SUNDRY NOTICES AND REPORTS ON WELLS (DO NOT USE THIS FORM FOR PROPOSALS TO DRILL OR TO DEEPEN OR PLUG BACK TO A DIFFERENT RESERVOIR. USE "APPLICATION FOR PERMIT" (FORM C-101) FOR SUCH PROPOSALS.)		WELL API NO. 30-025-35550
1. Type of Well: Oil Well Gas Well ☒ Other		5. Indicate Type of Lease STATE X FEE
2. Name of Operator CIMAREX ENERGY CO. OF COLORADO		6. State Oil & Gas Lease No.
3. Address of Operator 600 N. MARIENFELD, SUITE 600, MIDLAND, TEXAS 79701		7. Lease Name or Unit Agreement Name MARY 12 STATE COM
4. Well Location Unit Letter O : 660 feet from the SOUTH line and 1880 feet from the EAST line Section 12 Township 21S Range 34E NMPM LEA County		8. Well Number 001Y
11. Elevation (Show whether DR, RKB, RT, GR, etc.) 3,690' – GR		9. OGRID Number 162683
		10. Pool name or Wildcat WILSON; MORROW

Well Name: Mary 12 State Com 1Y **API No.:** 30-025-35550
Field Name: Wilson **Location:** Sec 12 Twn 21S Rge 34E **Unit:**
County, State: Lea County, TX **Location:** 660' FSL & 1,880' FEL
Spud Date: 5/21/2001 **Compl. Date:** 7/17/2001 **GR:** 3,690' **KB:** 3,707' **DF:** 17'

Operator: CIMAREX ENERGY CO. OF COLORADO 6001 Deauville Blvd Midland, TX 79706	OGRID: 162683
	Action Number

PROPOSED

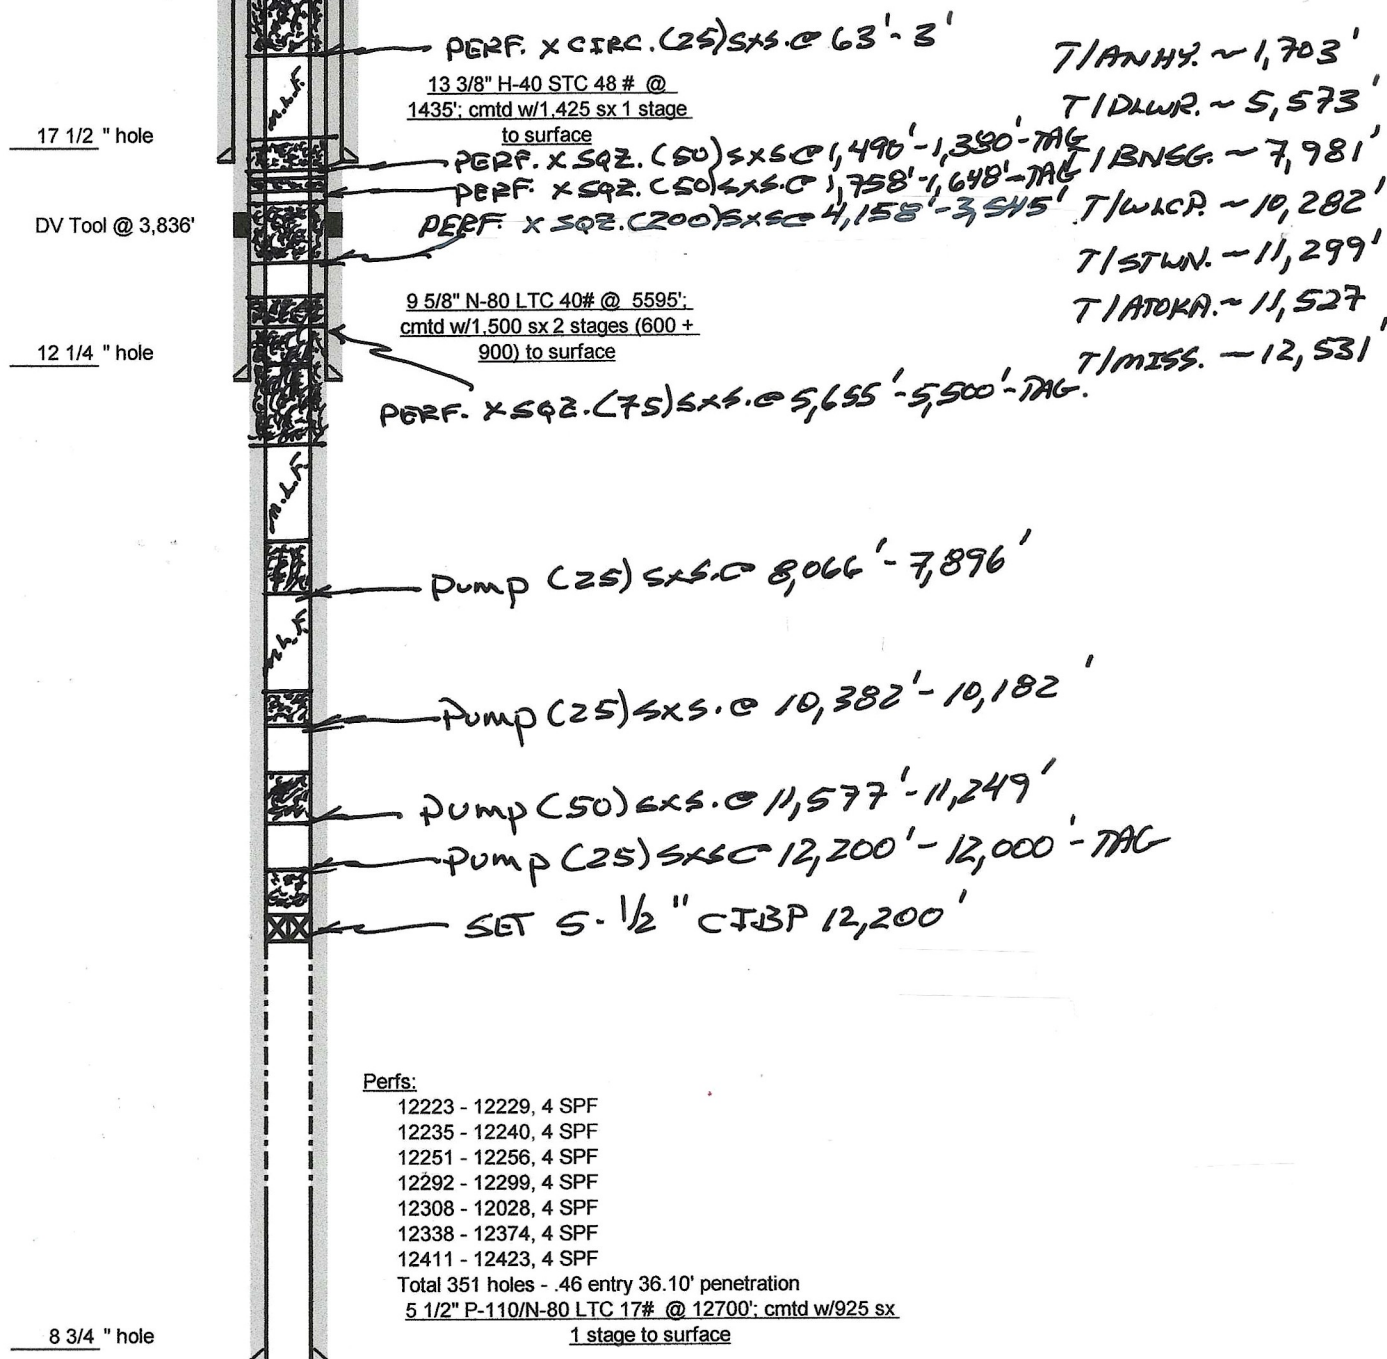
Spot 15 sx cmt 12585' - WOC & Tag 12485' or higher - T Miss

- 1) SET 5-1/2" CIBP 12,200'; CIRC. WELL W/ M.L.F.; PRES. TEST 5-1/2" CSG. TO 500# X HOLD; Bubble Test - RUN CBL to Surface
- 2) PUMP (25) SXS. CLASS "H" CMT. @ 12,200'-12,000'; WOC X TAG TOC.

Created By	Condition	Condition Date
gcordero	Run CBL to surface	5/29/2025
gcordero	A Cement Bond Log (CBL) is required to be submitted to electronic permitting.	5/29/2025
gcordero	Submit Cement Bond Logs (CBL) prior to submittal of C-103P.	5/29/2025
